State of New Mexico
Energy, Minerals and Natural Resources

SUNDRY NOTICES AND REPORTS ON WELLS (DO NOT USE THIS FORM FOR PROPOSALS TO DRILL OR TO DEEPEN OR PLUG BACK TO A DIFFERENT RESERVOIR. USE "APPLICATION FOR PERMIT" (FORM C-101) FOR SUCH PROPOSALS.)	
1. Type of Well: Oil Well ☐ Gas Well ☒ Other	
2. Name of Operator LINN OPERATING, INC.	
3. Address of Operator 600 TRAVIS ST., SUITE 5100 HOUSTON, TEXAS 77002	
4. Well Location Unit Letter H : 1980 feet from the NORTH line and 660 feet from the EAST line Section 03 Township 23S Range 36E NMPM LEA County	
11. Elevation (Show whether DR, RKB, RT, GR, etc.) 3511' GR

The SRQU #52 failed an MIT in February 2016 during the annual UIC testing. Linn respectfully requests to permanently plug and abandon this well. Please see the attached proposed plugging procedure as well as current and proposed well bore diagrams.

SEVEN RIVERS QUEEN UNIT #052 (309557)
LINN OPERATING, INC. (269324)
PROPOSAL TO PLUG AND ABANDON

Well Name: SEVEN RIVERS QUEEN UNIT 52

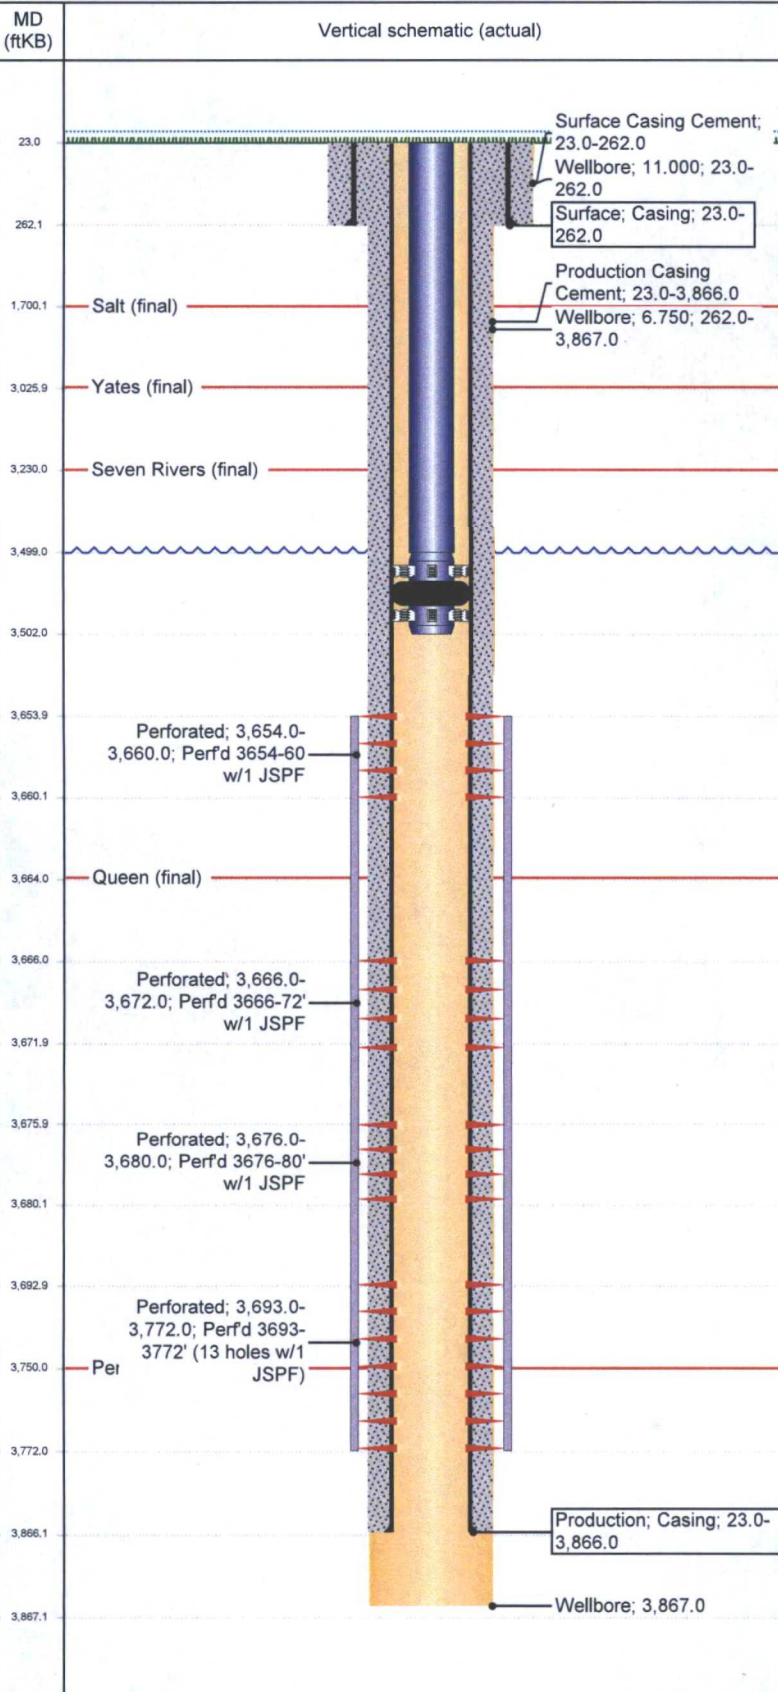
1. Set 4-1/2" CIBP @ 3600' w/25 sxs cmt
2. Circulate hole w/mud laden fluid. *Pressure test csg. Report results.*
3. Spot 25 sxs cmt @ 2900' - 2530'.
4. Spot 25 sxs cmt @ ~~1700' - 1330'~~ *1500'*
5. Perf & Sqz ~~30~~ sxs cmt @ 315' ~~- 215'~~ WOC & Tag. — *CIRC TO SURFACE*
6. ~~Perf & Sqz 30 sxs cmt @ 100' & circulate to surface.~~
7. Cut off wellhead and weld on Dry Hole Marker.

Verify cement to surface

Well Name: SEVEN RIVERS QUEEN UNIT 52

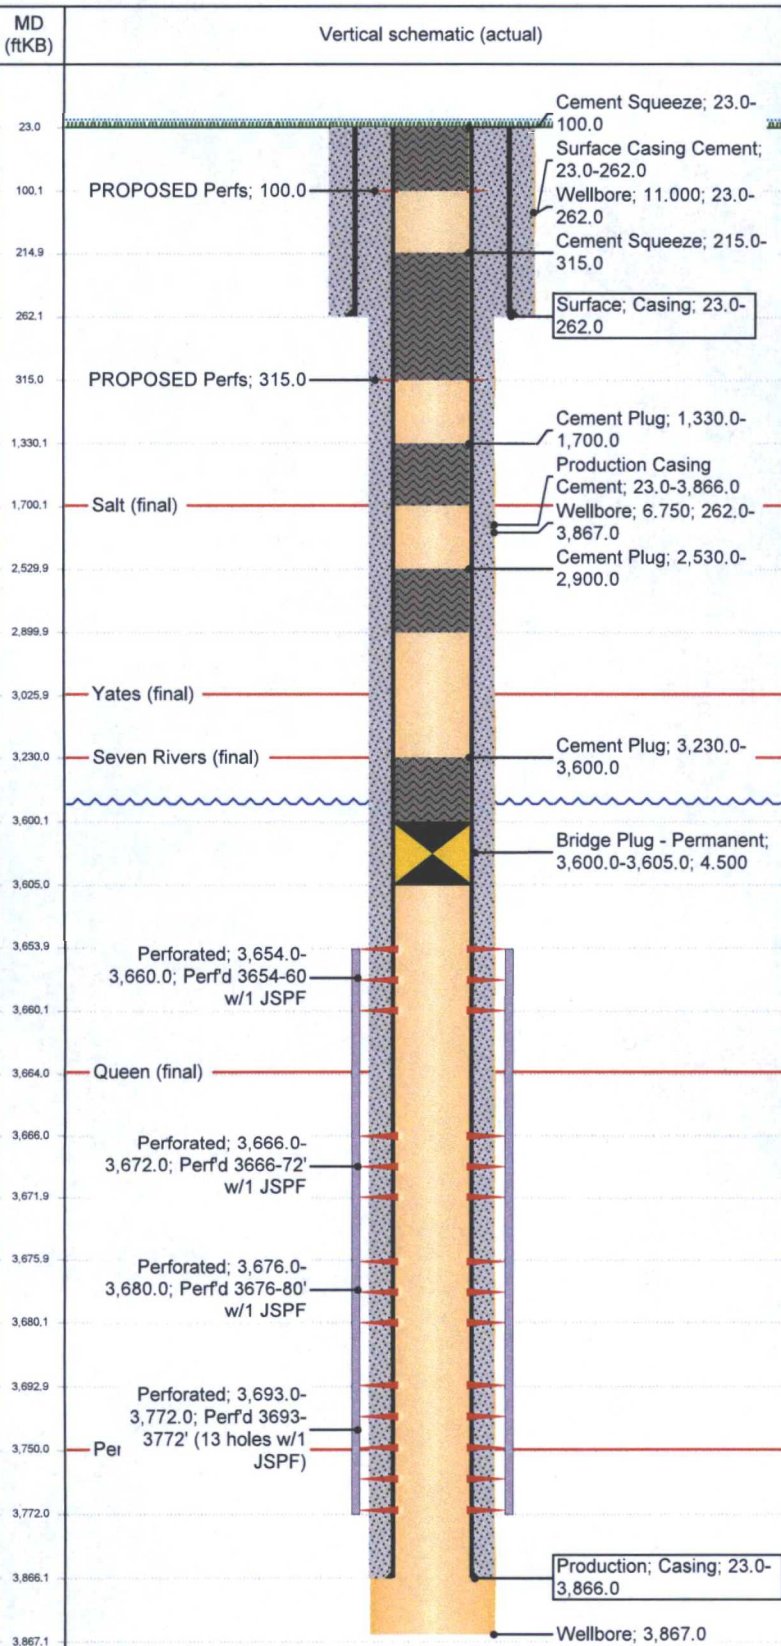
Wellbores						
North-South Distance (ft)		NS Flag		East-West Distance (ft)		EW Flag
Casing Strings						
Csg Des Surface	Set Dept... 262.0	OD Nom... 8 5/8	ID Nom... 8.097	Wt/Len (l... 24.00	String Grade J-55	Run Date 9/14/1960
Csg Des Production	Set Dept... 3,866.0	OD Nom... 4 1/2	ID Nom... 4.09	Wt/Len (l... 9.50	String Grade J-55	Run Date 9/23/1960
Cement Stages						
Description Cement Plug	Top (ftKB) 3,230.0	Btm (ftKB) 3,600.0	Eval Method	Comment PROPOSED: Cap CIBP w 25 sks cmt		
Description Cement Plug	Top (ftKB) 2,530.0	Btm (ftKB) 2,900.0	Eval Method	Comment PROPOSED: Spot 25 sks cmt at 2900'-2530'		
Description Cement Plug	Top (ftKB) 1,330.0	Btm (ftKB) 1,700.0	Eval Method	Comment PROPOSED: Spot 25 sks cmt at 1700'-1330'		
Description Cement Plug	Top (ftKB) 215.0	Btm (ftKB) 315.0	Eval Method	Comment PROPOSED: Perf and Sqz 30 sks cmt at 315'- 215'. Tag TOC.		
Description Cement Plug	Top (ftKB) 23.0	Btm (ftKB) 100.0	Eval Method	Comment PROPOSED: Perf and Sqz 30 sks cmt at 100'. Circ to surface.

Description Surface Casing Cement	Top (ftKB) 23.0	Btm (ftKB) 262.0	Eval Method	Comment Cmt'd w/200 sx cmt. Circ cmt to surf		
Description Production Casing Cement	Top (ftKB) 23.0	Btm (ftKB) 3,866.0	Eval Method	Comment Cmt'd w/1635 sx cmt. Circ cmt to surf		
Tubing Strings						
Tubing Description Tubing		Set Depth... 3,502.0	Run Date 9/22/2011	Pull Date 8/31/2016		
Perforations						
Top (ftKB) 100.0	Btm (ftKB) 100.0	Comment				
Top (ftKB) 315.0	Btm (ftKB) 315.0	Comment				
Top (ftKB) 3,654.0	Btm (ftKB) 3,660.0	Comment Perf'd 3654-60 w/1 JSPF				
Top (ftKB) 3,666.0	Btm (ftKB) 3,672.0	Comment Perf'd 3666-72' w/1 JSPF				
Top (ftKB) 3,676.0	Btm (ftKB) 3,680.0	Comment Perf'd 3676-80' w/1 JSPF				
Top (ftKB) 3,693.0	Btm (ftKB) 3,772.0	Comment Perf'd 3693-3772' (13 holes w/1 JSPF)				
Other In Hole						
Des	Top (ftKB)	Btm (ftKB)	Run Date	Com		
Bridge Plug - Permanent	3,600.0	3,605.0		PROPOSED: Set CIBP at 3600' and cap w 25 sks cmt.
